CONSTRUCTION COMMITTEE MEETING AGENDA

DATE: **Tuesday, June 18, 2024**
TIME: **9:00 a.m.**
PLACE: **Carl T. Langford Board Room, Orlando International Airport, One Jeff Fuqua Blvd., Orlando, FL 32827**

CONSTRUCTION COMMITTEE MEETING
CHANGE ORDER AGENDA
Tuesday, June 18, 2024

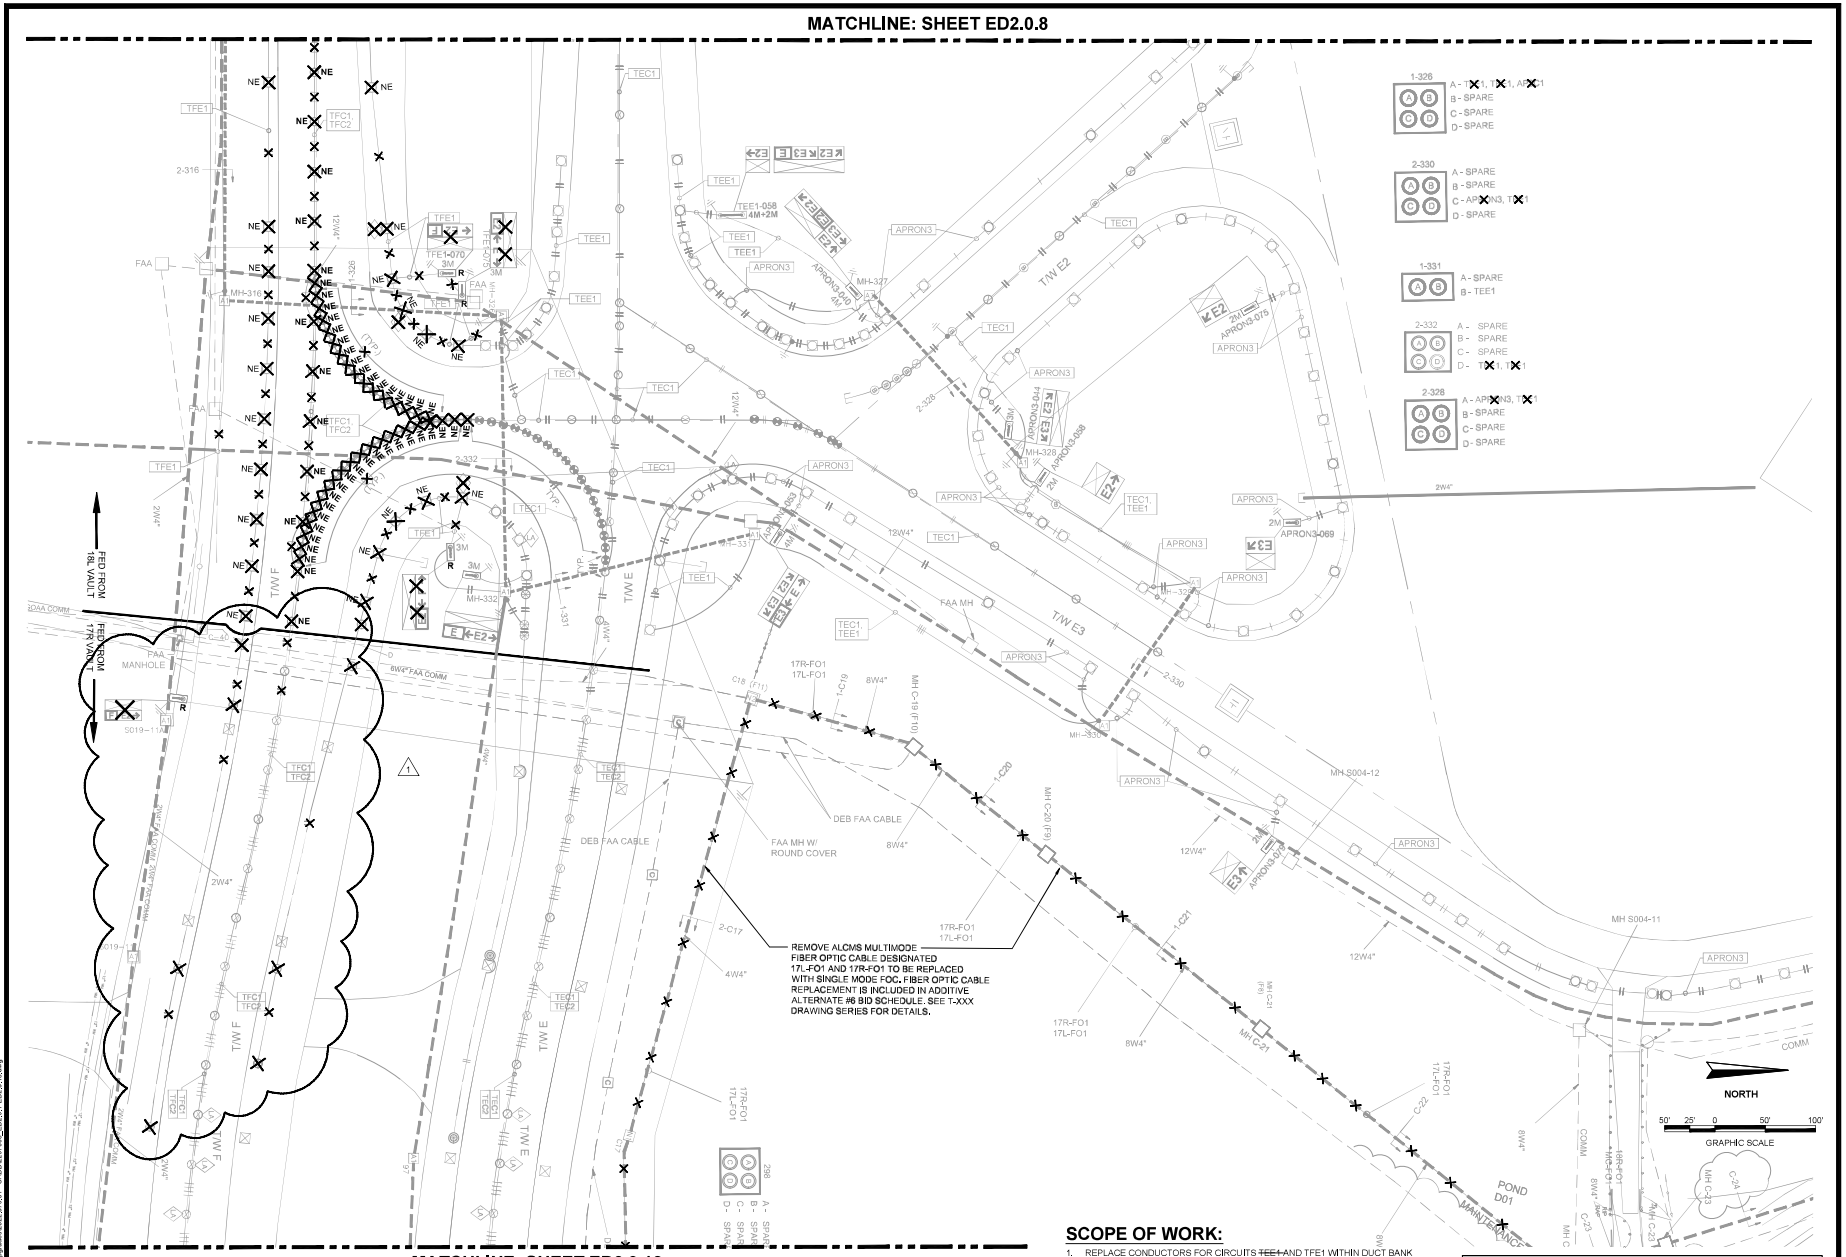
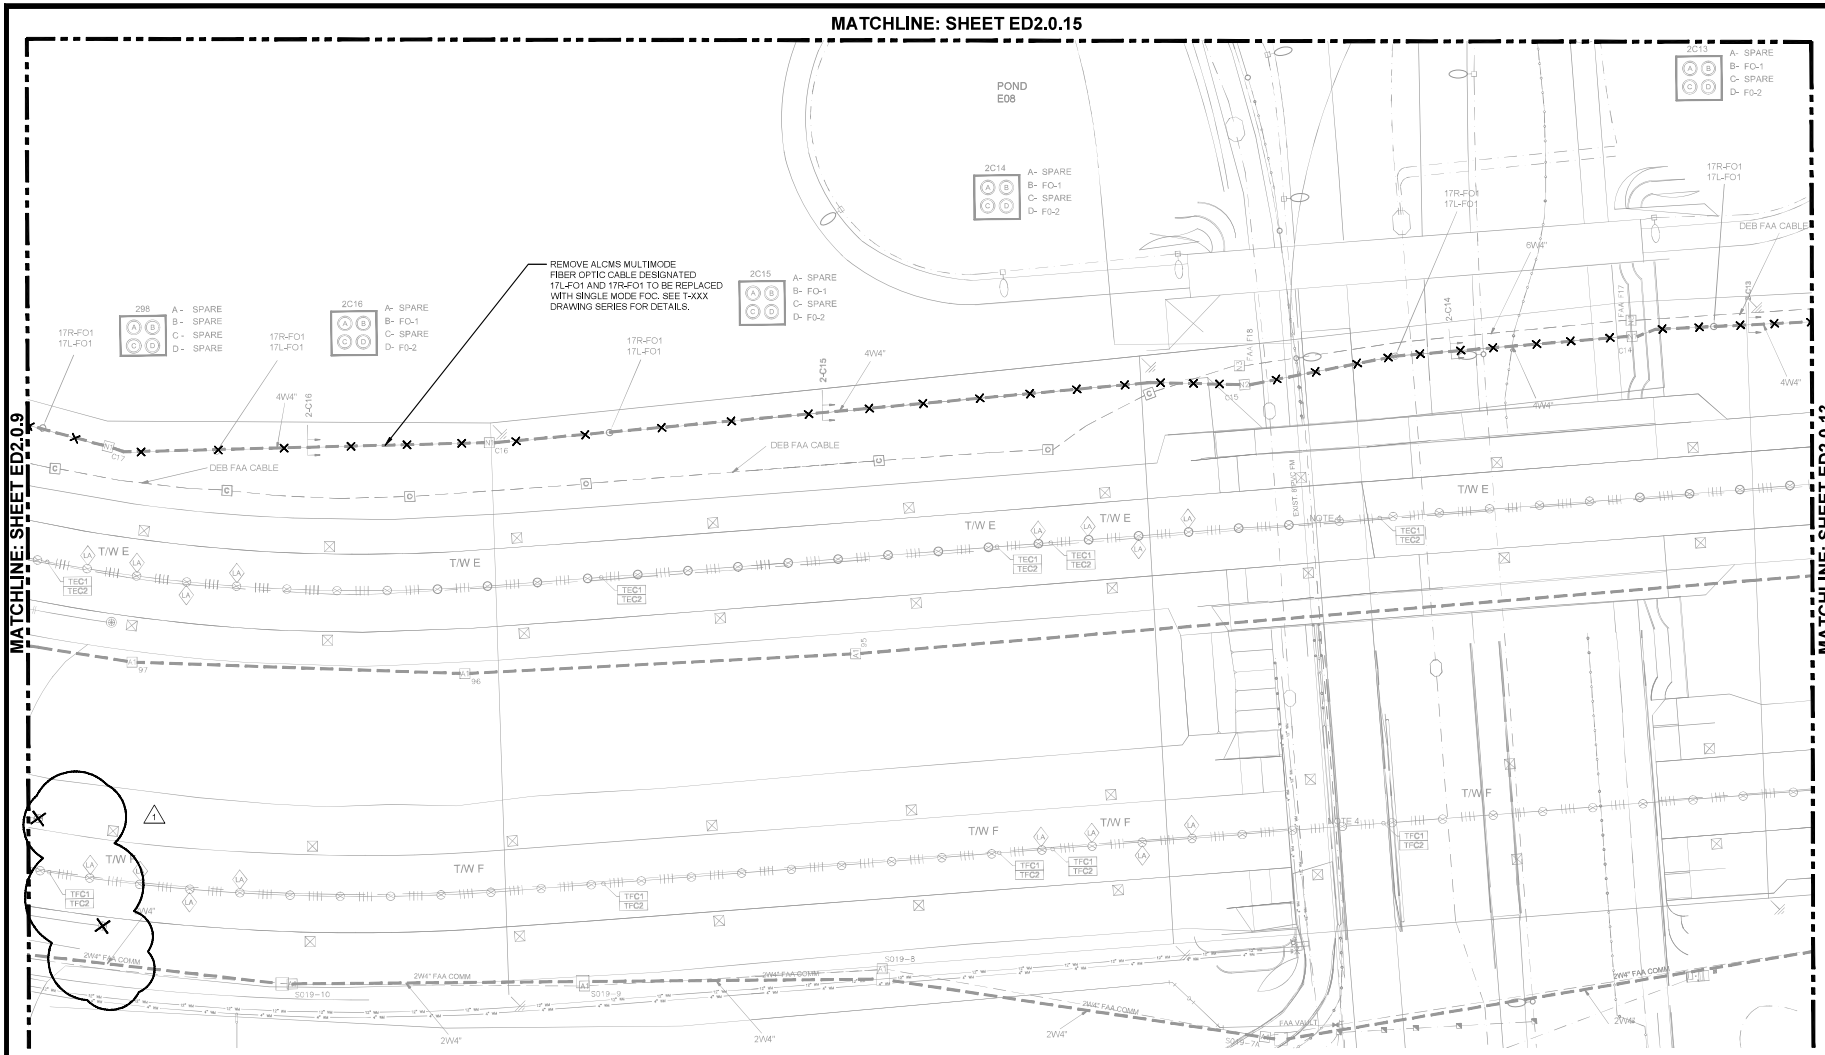
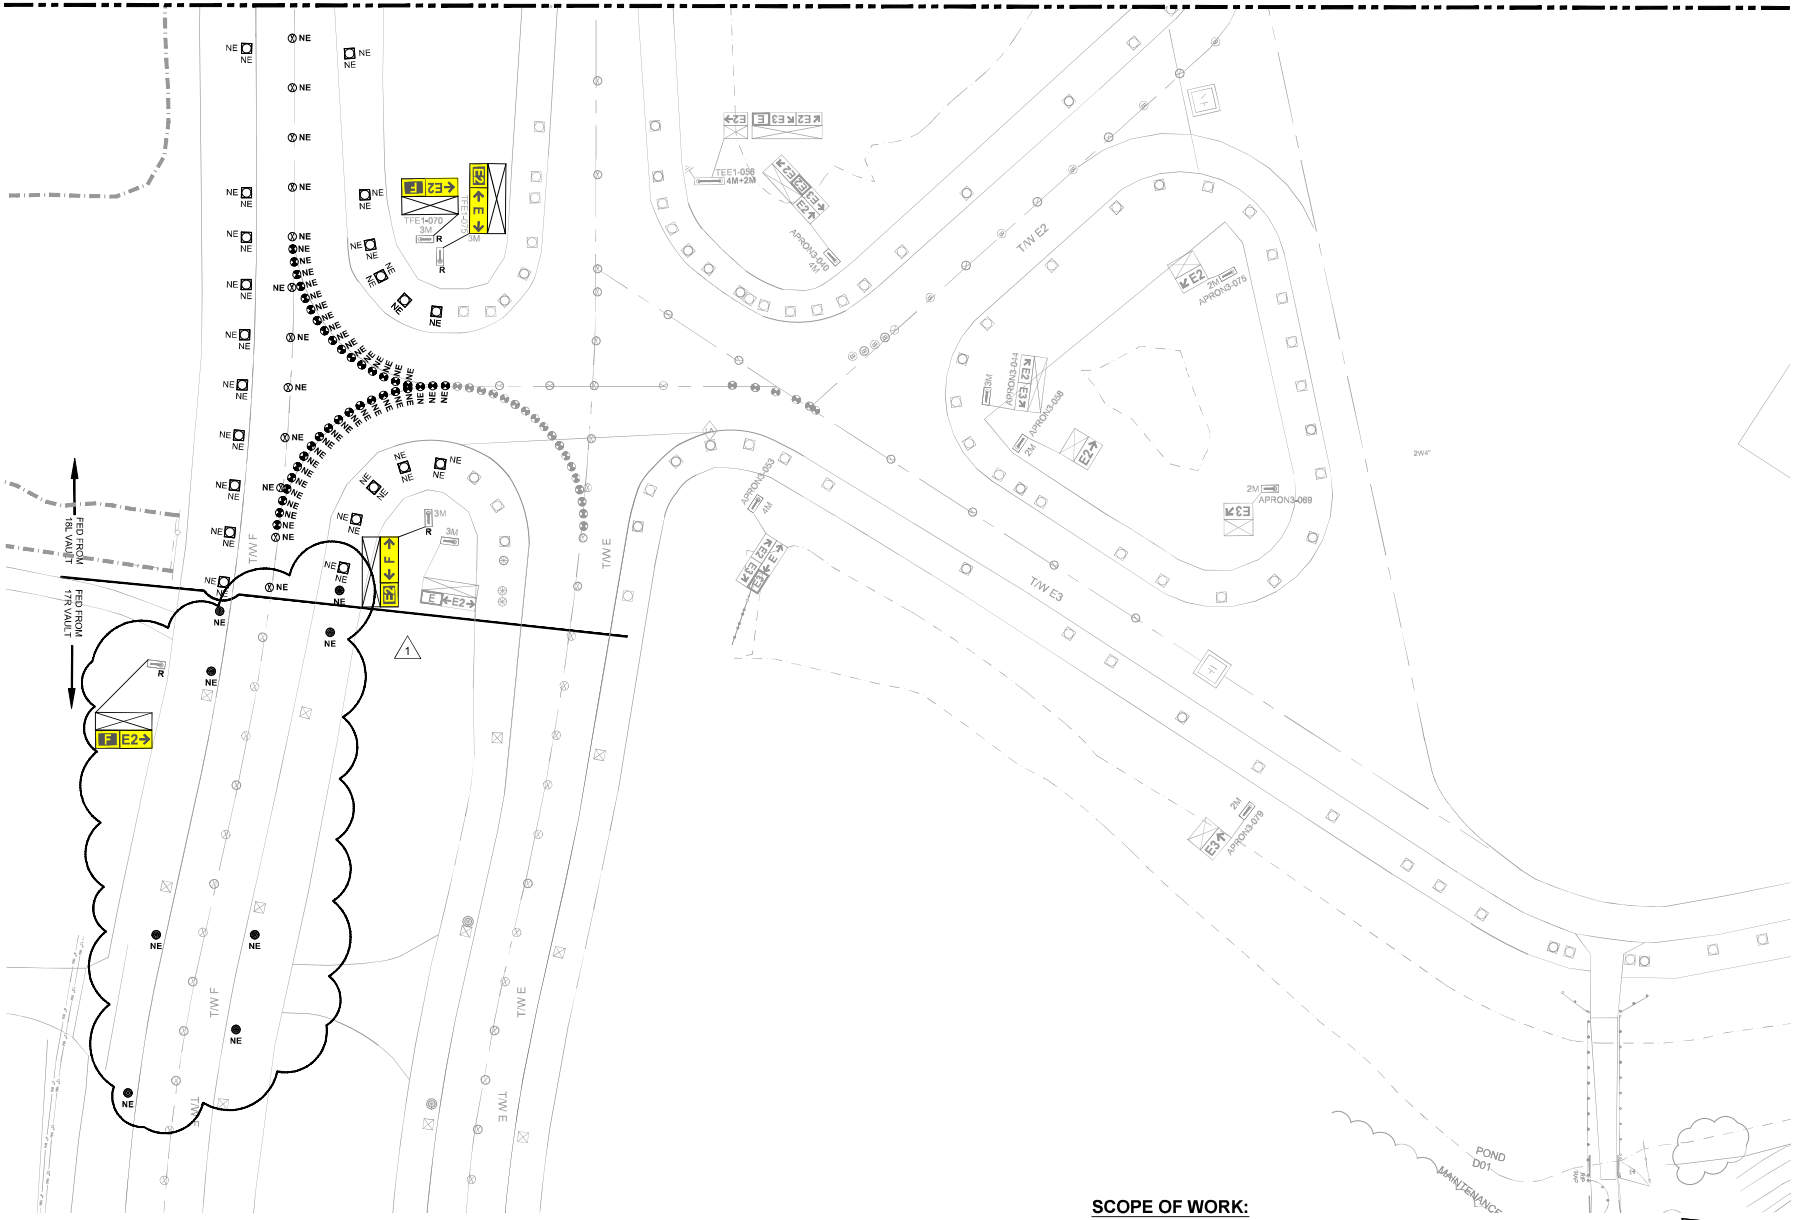
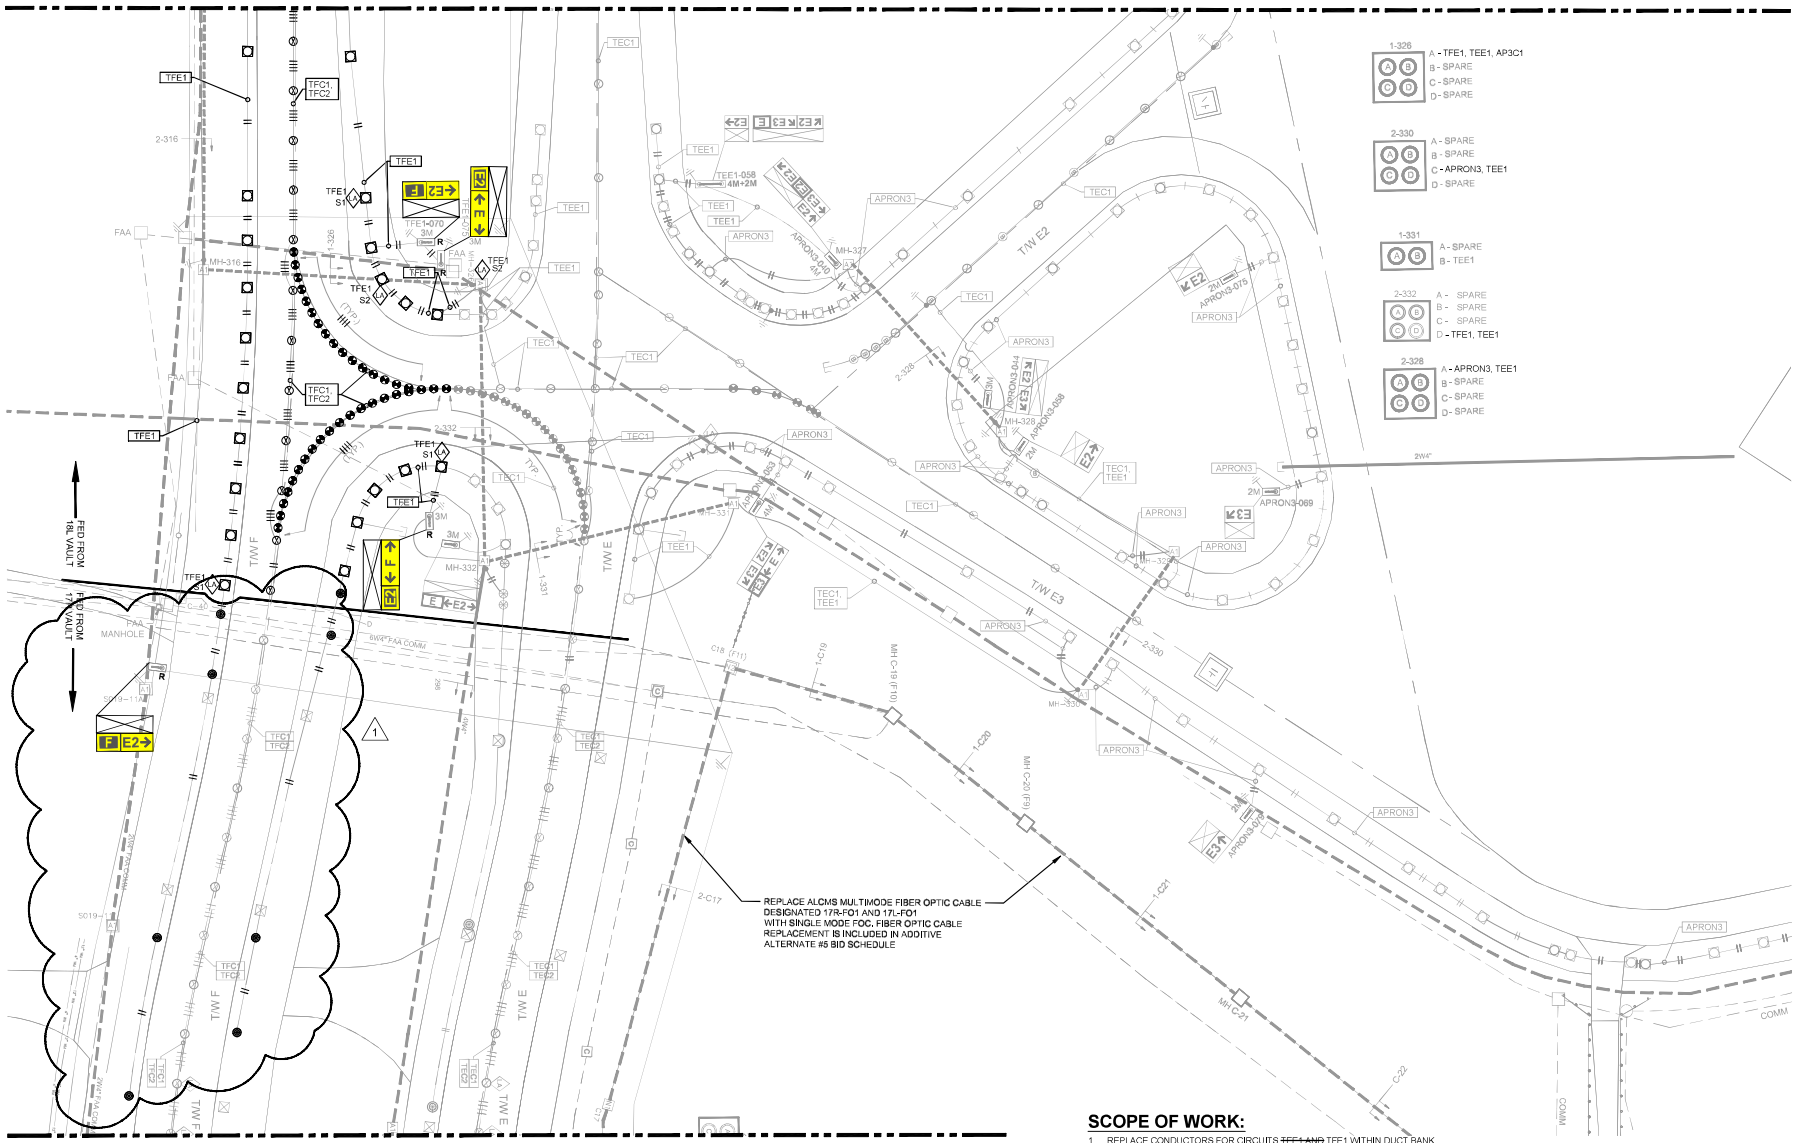
Description:
Eight Red Semiflush Taxiway Edge Fixture and one sign have been added to the scope of work. The lights will be installed on existing base cans and the sign installed on existing concrete pad. The following plan sheets have been revised: ED2.0.9, ED2.0.12, E.2.1.9, E2.2.9, E2.2.12, and E7.0.4.

Attachments:
The following sheets have been revised and are attached to this ESI #1: ED2.0.9, ED2.0.12, E.2.1.9, E2.2.9, E2.2.12, and E7.0.4.
